NEW MEXICO OIL CONSERVATION DIVISION - Engineering Bureau - 1220 South St. Francis Drive, Santa Fe, NM 87505

OGRID 230930 API well Name Lakewood SWD #2 Located F-9-195-26E B-9-195-26E API 30-015-21319

APPLICATION FOR AUTHORIZATION TO INJECT

Subject: Disposal application from COG Operating, LLC: proposed Lakewood SWD #2 30-015-NA 1470fnl 1980fwl F/9/19S/26E Eddy Canyon formation perforated from 7720 to 8000 feet

Well: Samedan Oil Corp.

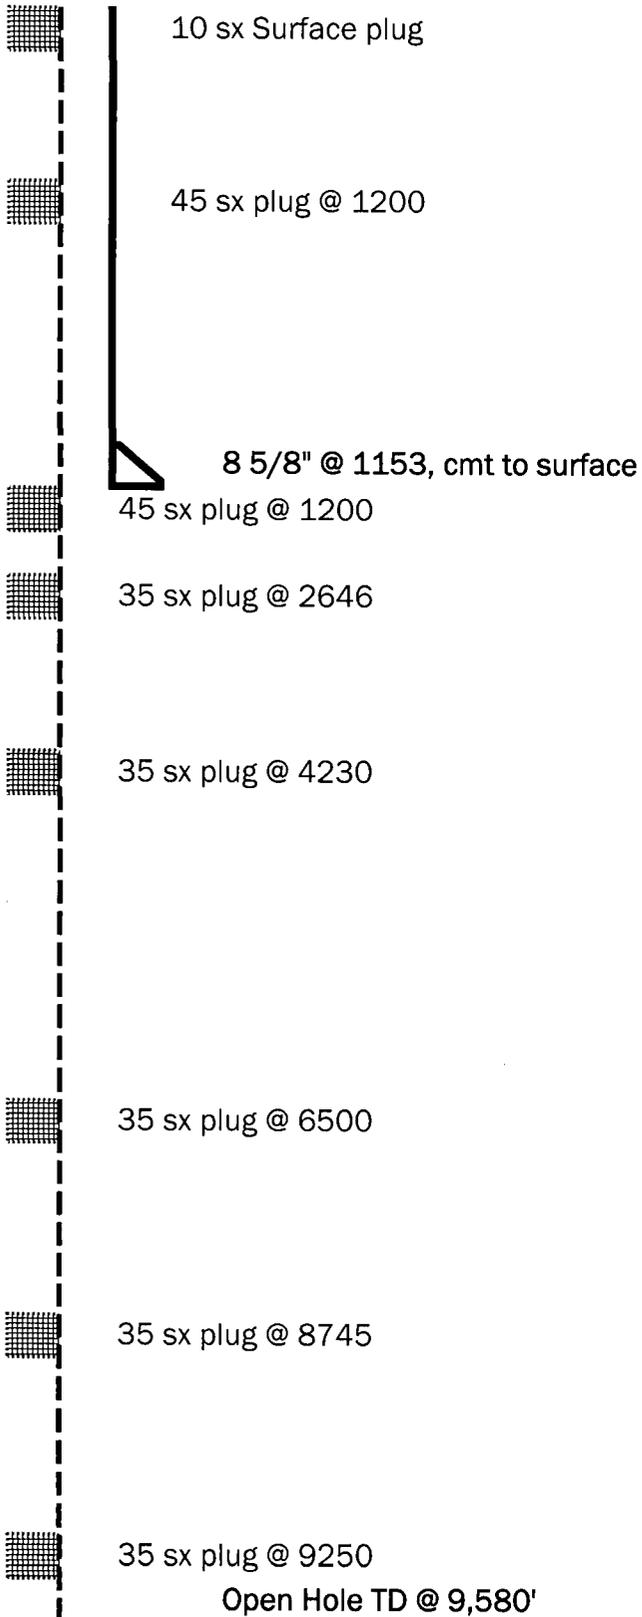
The application showed one P&Aed AOR well without any wellbore diagram. From the Division's web site it appears this was a dry hole drilled to 9580 feet and plugged without running casing. The plugs were set 8745 feet which seems to be at the top of the Strawn and at 6500 feet which may be somewhere in the Wolfcamp formation.

The application showed one P&Aed AOR well without any wellbore diagram. From the Division's web site it appears this was a dry hole drilled to 9580 feet and plugged without running casing. The plugs were set 8745 feet which seems to be at the top of the Strawn and at 6500 feet which may be somewhere in the Wolfcamp formation.

The application showed one P&Aed AOR well without any wellbore diagram. From the Division's web site it appears this was a dry hole drilled to 9580 feet and plugged without running casing. The plugs were set 8745 feet which seems to be at the top of the Strawn and at 6500 feet which may be somewhere in the Wolfcamp formation.

1. A wbd of the Samedan P&A is attached.
2. A map is shown below.
3. See if this is correct
 - a. We send cert'd ltr to all 'affected persons' the notice list
 - b. We include the P&A wbd
 - c. what does 'explain that the SWD well is unbounded' mean?
 - d. Dunno exactly what you want me to write?

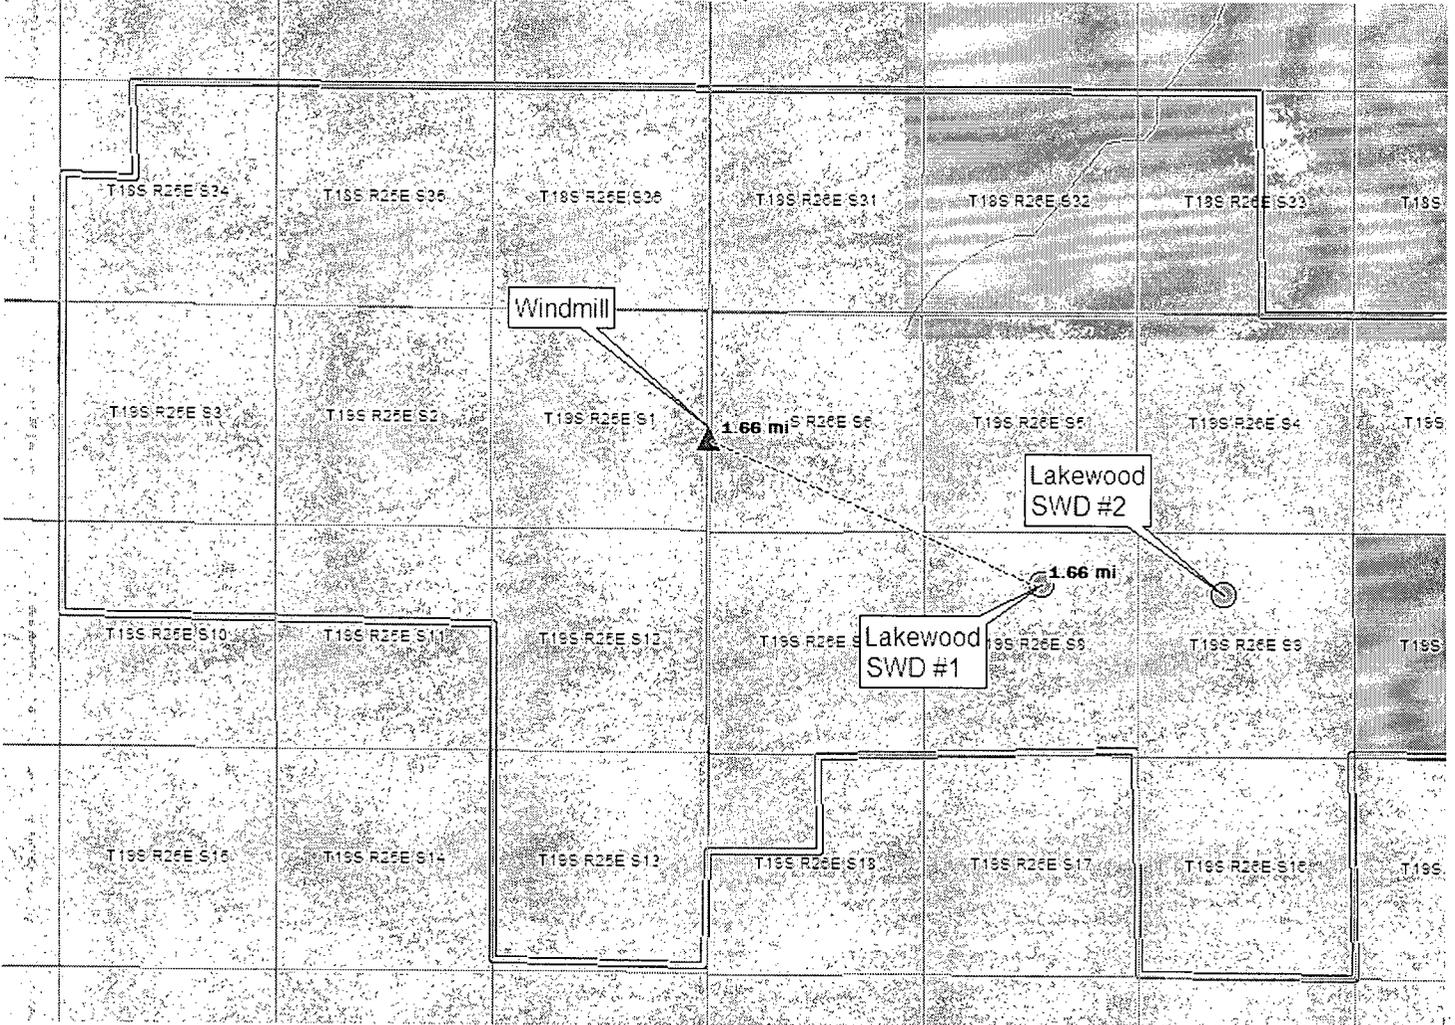
1. Who owns the surface at this proposed well site and were they noticed (the application does not say)
2. Please send the proof of notice to Edith Young and L.G. Wilson – I did not find those certifications in the application.
3. Would you send me the depth you will use for DV tool in this proposed well and the cementing volumes above and below that stage tool.
4. Send a wellbore diagram of the plugged well in the Area of Review – there is data on the OCD web site about this well – see below.
5. Are there any fresh water sources (windmills located by your field people) within 1 mile of this location?

Will, we are 1.66 miles from this windmill, please see below.

COG_LAKEWOOD_SW2D2_XSEC_NMOCD.jpg

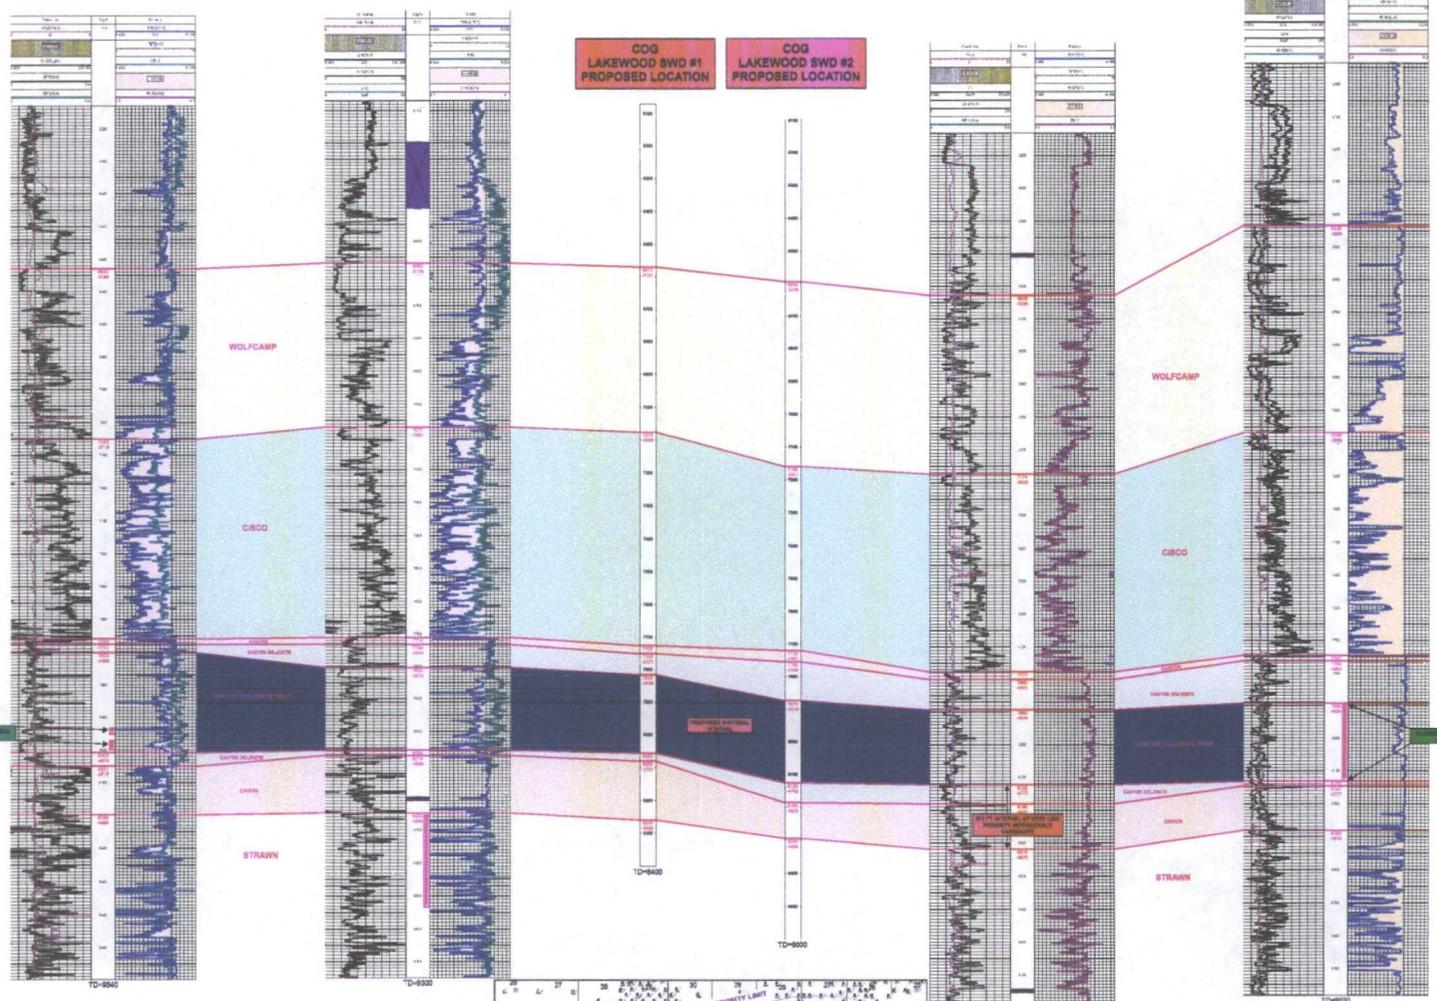
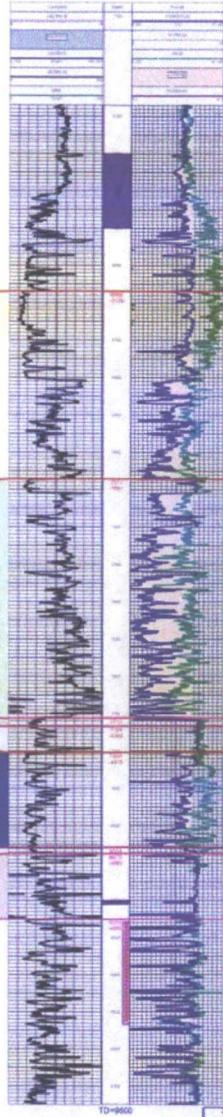
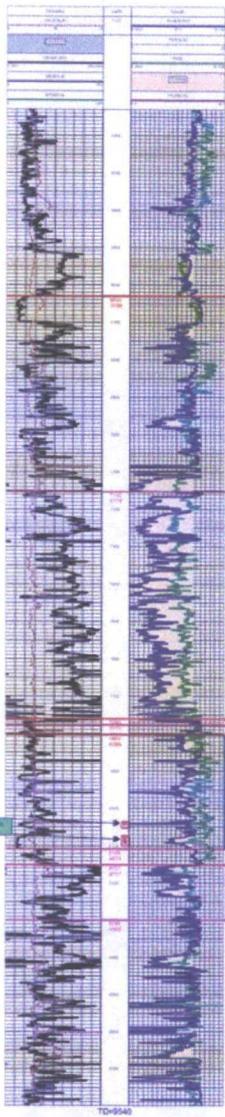
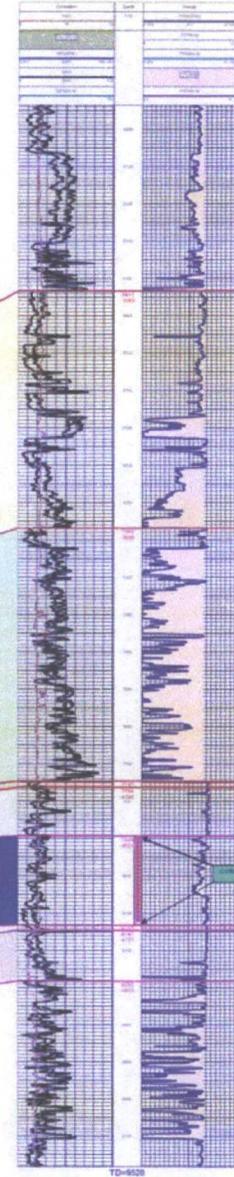
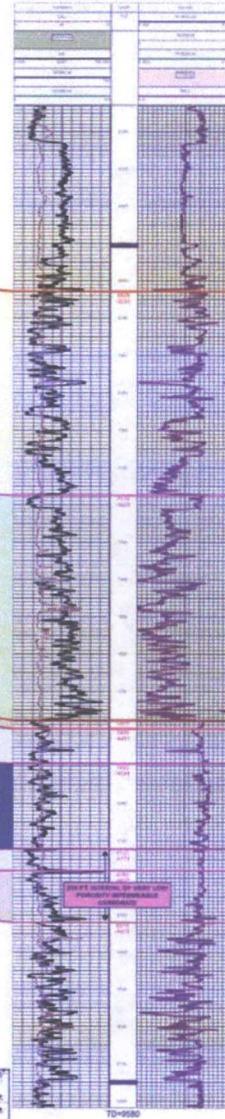
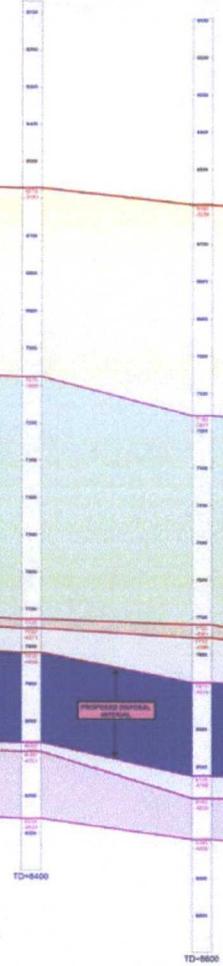
Did your Geologist see any possible productive potential of the expanded depth interval between those two plugs in that Area of Review well?

1. This letter will go out today, just a couple of minor tweaks, I really liked your letter best.
2. Working on a cross section for justification of expansion of the disposal but showing the boundaries that will prevent disposal migration to other zones.
